**CITY OF LINO LAKES  
PLANNING & ZONING BOARD MEETING**

**PLANNING & ZONING BOARD  
AGENDA ITEM 5A**

REQUEST: **PUBLIC HEARING**  
Century Farm North 7<sup>th</sup> Addition  
1. Preliminary Plat  
2. PUD Final Plan/Final Plat

**Re:** *Century Farms North 7<sup>th</sup> Addition  
Plan Review  
WSB Project No. 2988-200*

SHEET TITLE  
**SITE LAYOUT PLAN**

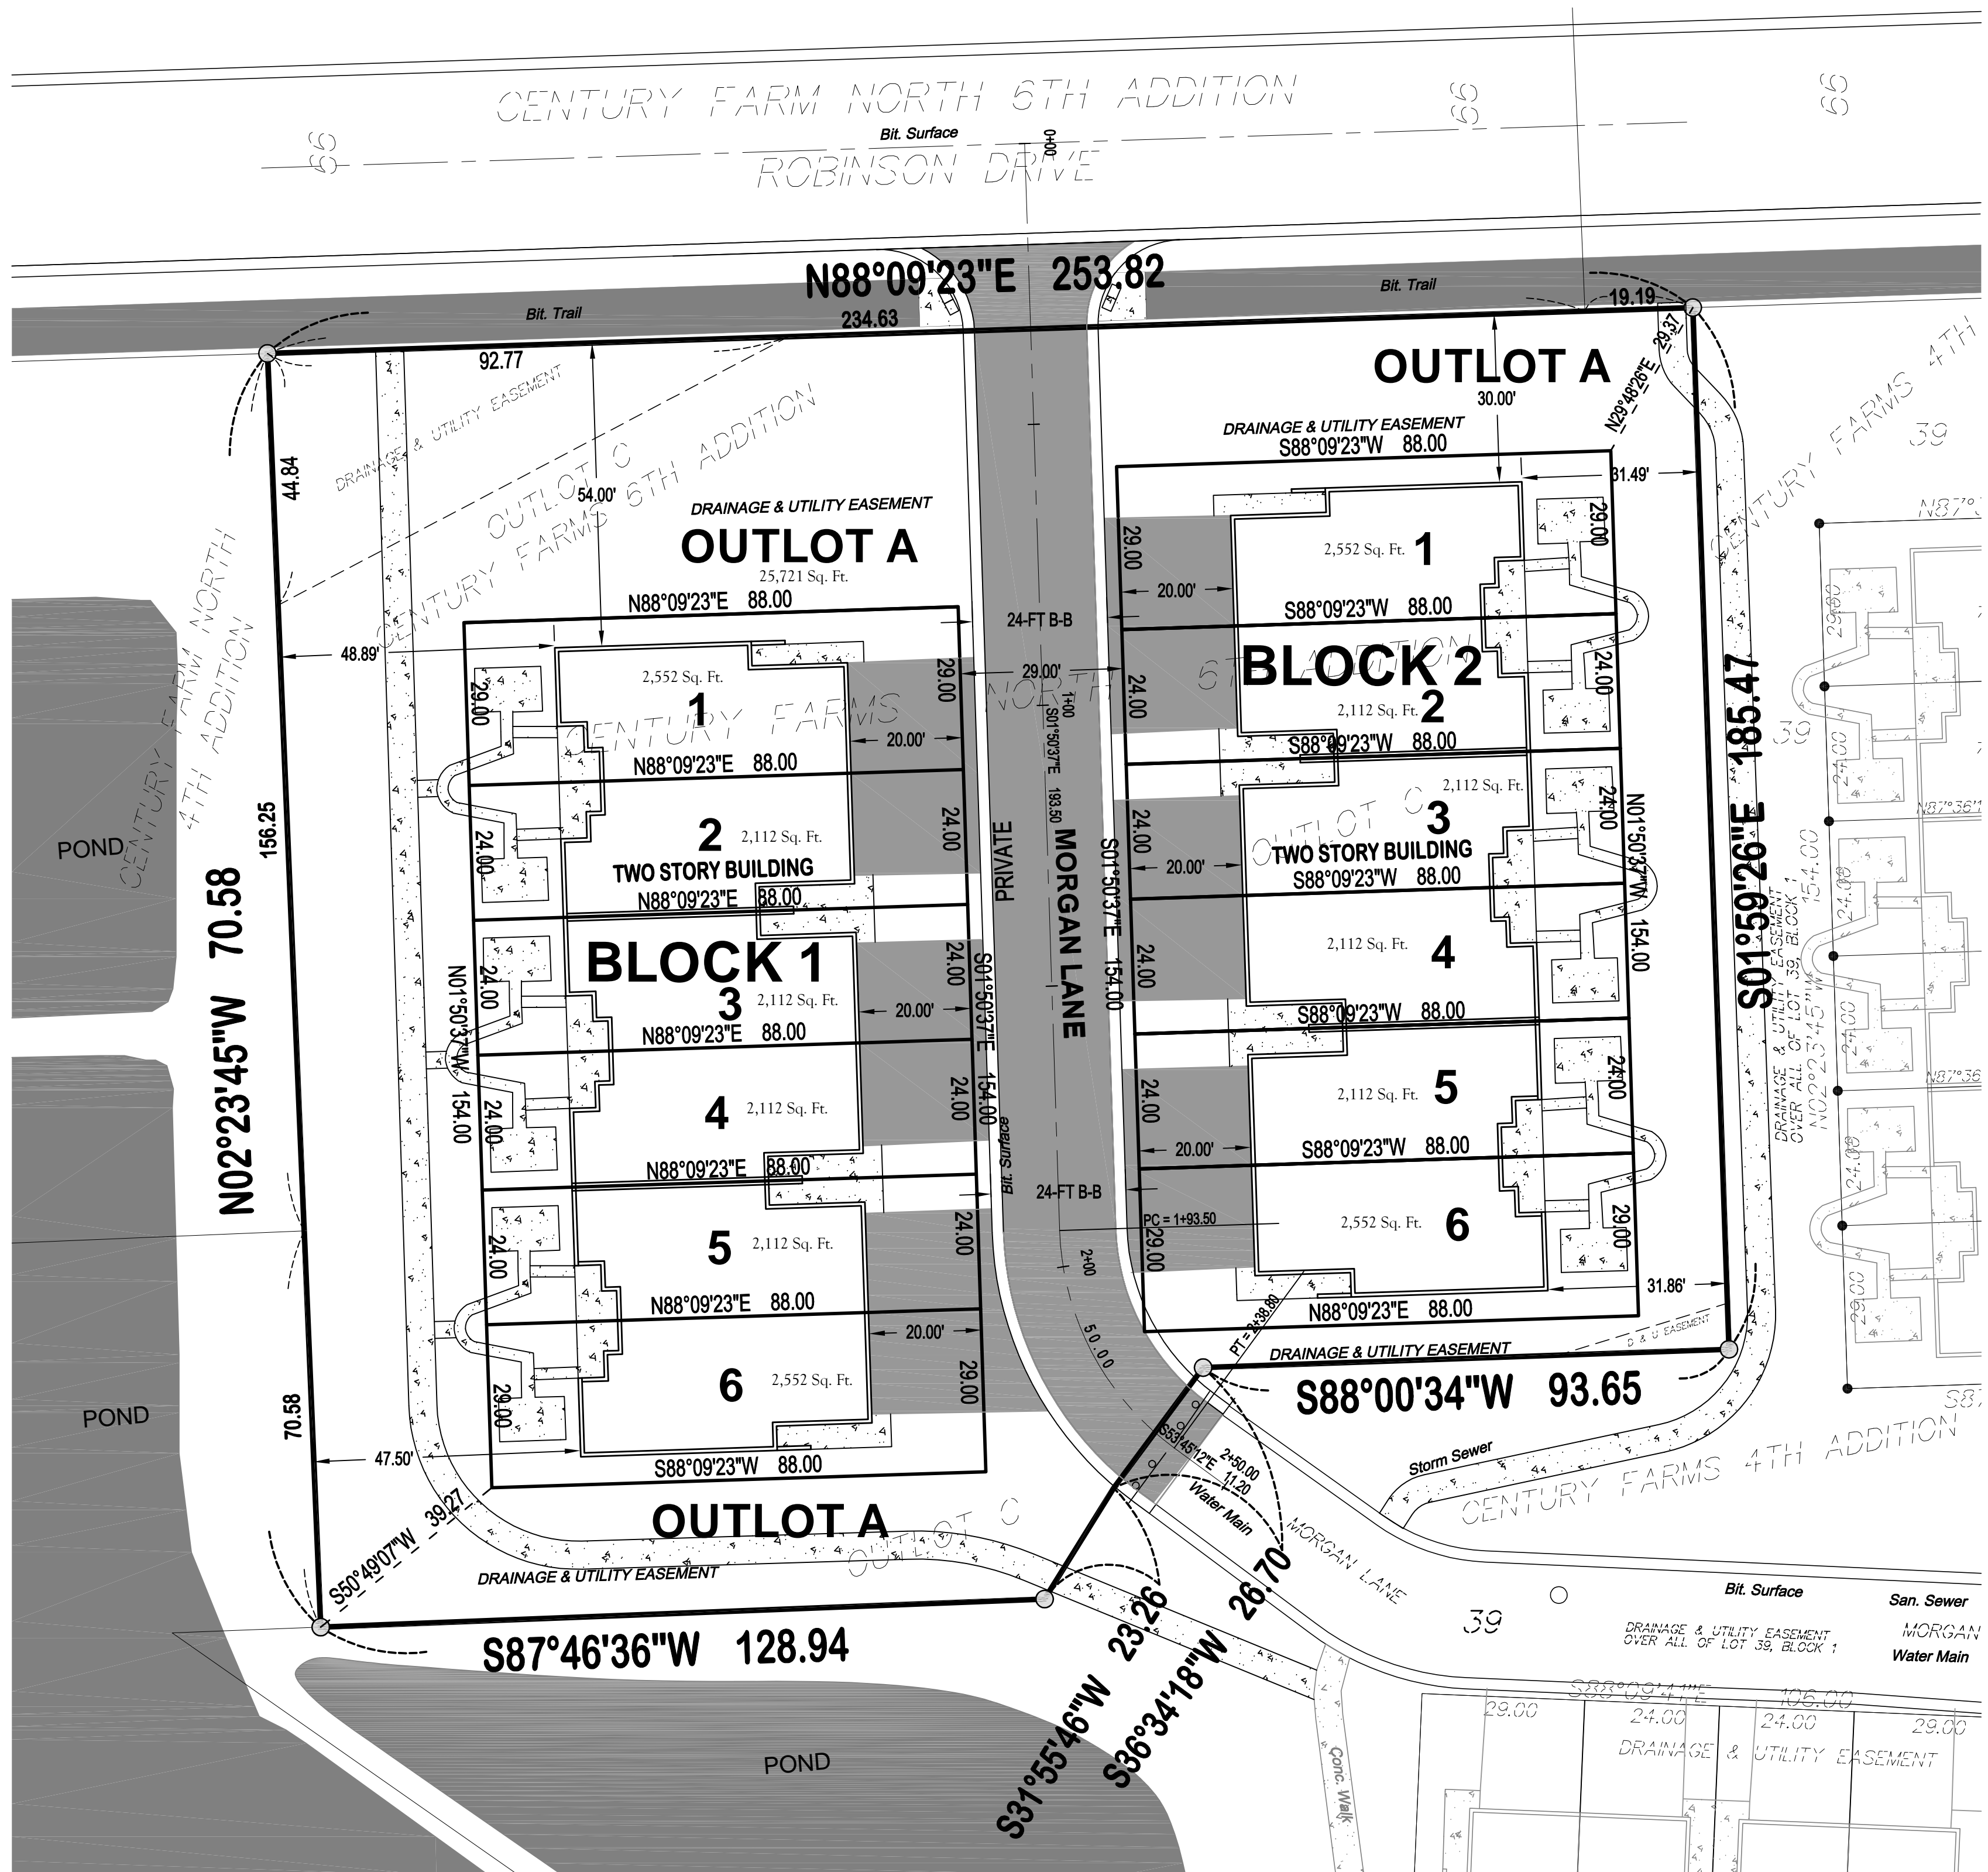
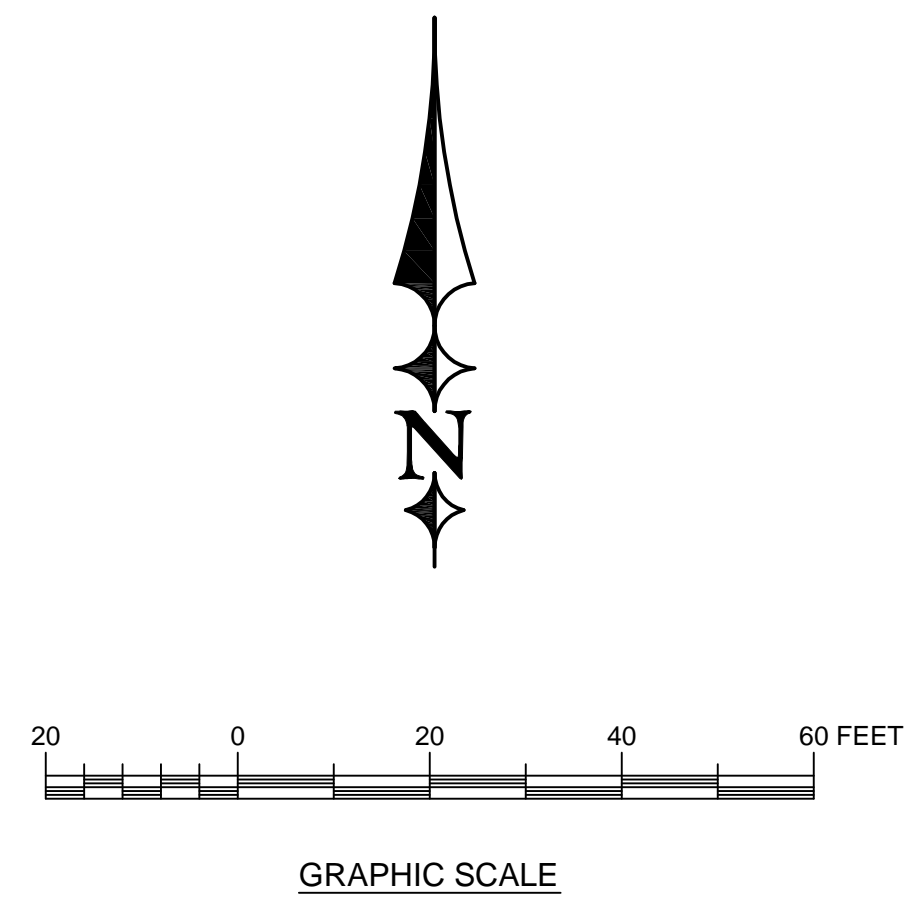
13. Sheet C4, Site Layout Plan:
  - a. The plan shall be revised to show sidewalk extending from Units 1-6, Block 2 to the sidewalk to the east.
  - b. Sidewalk shall also be extended from the townhome units on Gotland Lane to the sidewalk.

SHEET TITLE  
**GRADING &  
 EROSION  
 CONTROL PLAN**

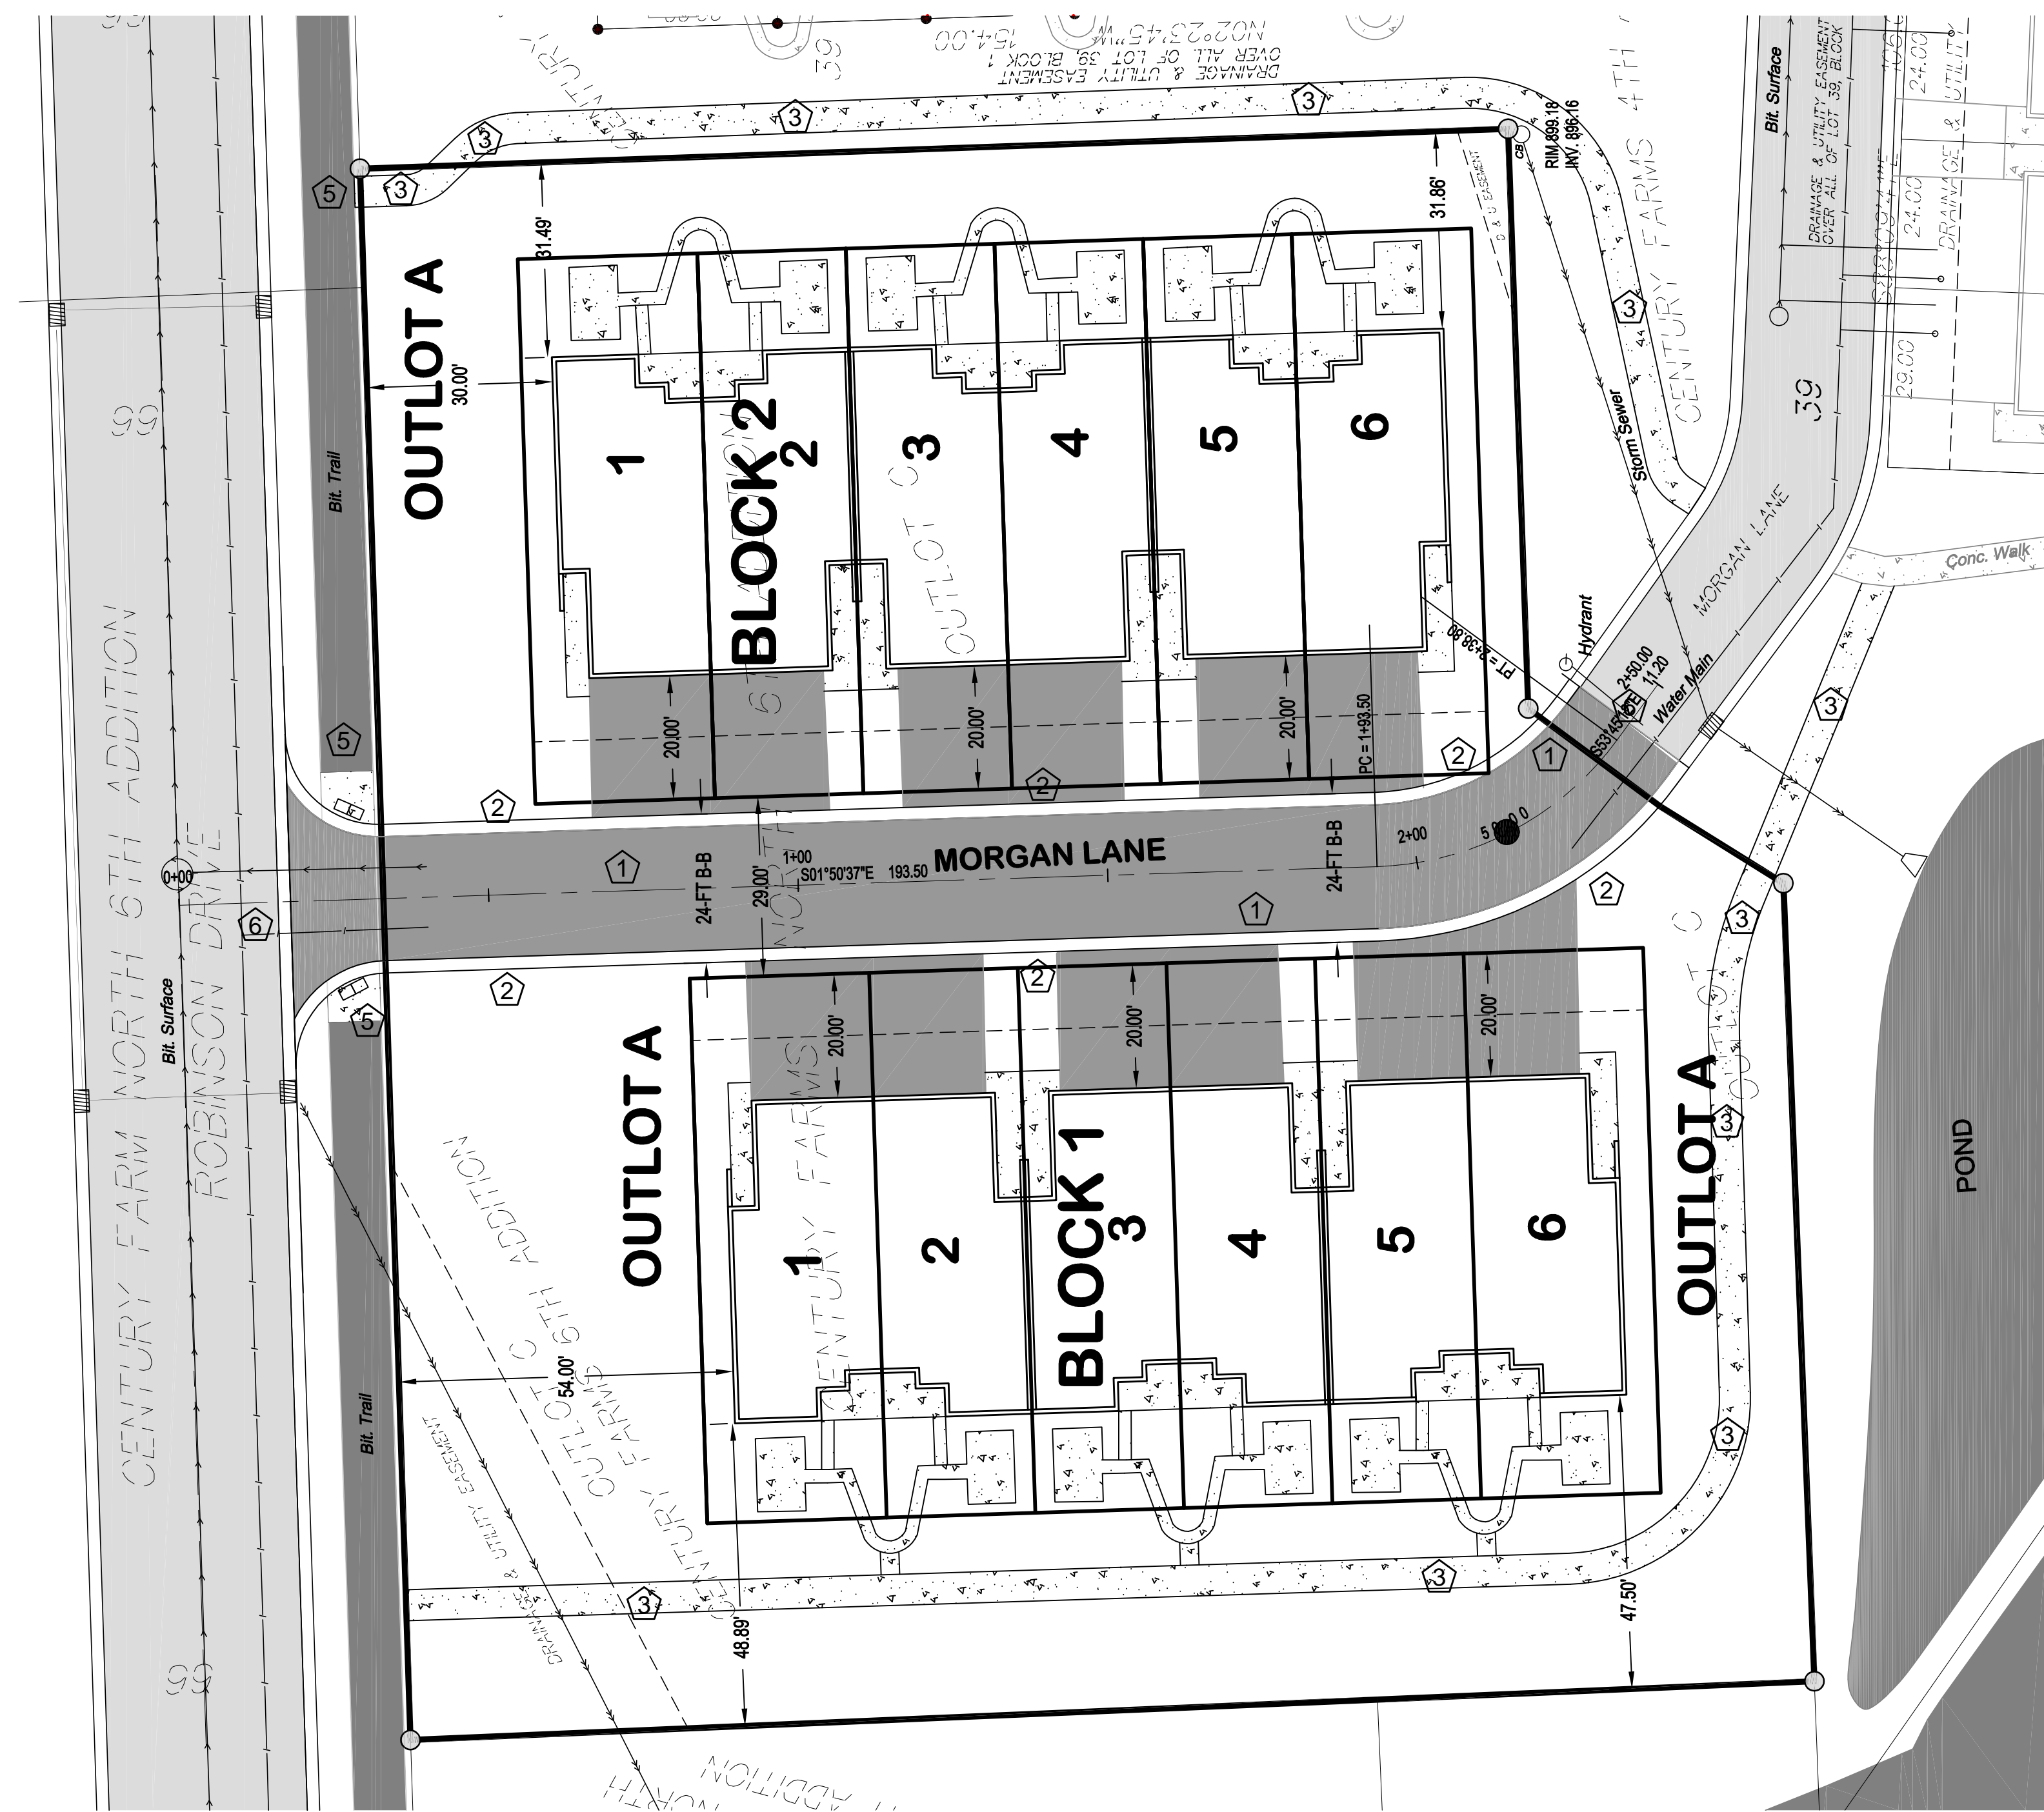
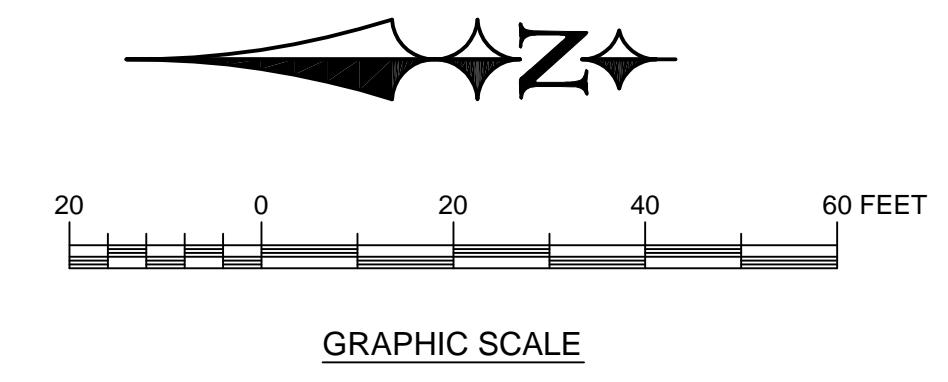
1. The applicant shall verify that the SWPPP was developed by a certified professional and include the certification cards.
2. The applicant shall label the receiving waters and denote the project discharge point(s).

3. The applicant shall label required buffer distances from surface waters/wetlands. If buffer distance cannot be maintained, call out that with a note on the plan sheet and provide redundant perimeter control BMPs. Area to the SW of the project.

4. The applicant shall label stormwater direction of flow arrows pre-construction.
5. The applicant shall list the soil types associated within the project boundary.

6. Show locations for temporary/permanent erosion control measures and the estimated quantities for all BMPs. Describe the temporary cover measures if permanent can not be installed within 7 days. Locations of temporary and permanent measures needed. List the seed mix that will be installed with the blanket/mulch measures and list the estimated quantities.

7. Show locations for stockpiles and BMP measures for stockpile management.
8. Denote the inspection process/schedule for SWPPP activities as well as the person(s) to ensure the inspections and maintenance activities are being performed.
9. The contour lines shall be extended 100 feet beyond the plat. This is specifically needed to review the sidewalk grades.
10. The existing drainage and utility easements shall be shown and labeled on the grading plans.
11. The sidewalk grade at the south east corner (near the existing catch basin) is 10% and shall be reduced.
12. The stormwater ponds need to be labeled with NWL, HWL, and pond bottom elevations.
13. The applicant needs to label the EOF locations for the ponds/wetlands.
14. The applicant needs to include the standard detail plates for Lino Lakes.
15. Note 4 "Grading and Erosion Control" can be removed.
